PACKARD MOTOR CAR COMPANY

March 18, 1930

SUBJECT: VENTILATOR LEAKS

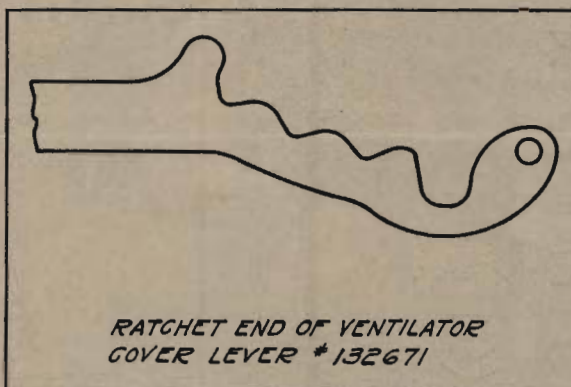
A change has recently been made in the ventilator cover lever, piece No. 132671, which has been very successful in correcting ventilator leaks.

The illustration shows the manner in which the last notch in the lever has been deepened. This is the notch which is engaged when the ventilator is in the closed position. The increased depth of the notch greatly increases the pressure holding the ventilator lid against the rubber gasket.

In cases where ventilator leaks are encountered the old lever may be replaced with a new one, or you may simply use one of the new levers as a marking template in order to file the notch to coincide with the new pattern.
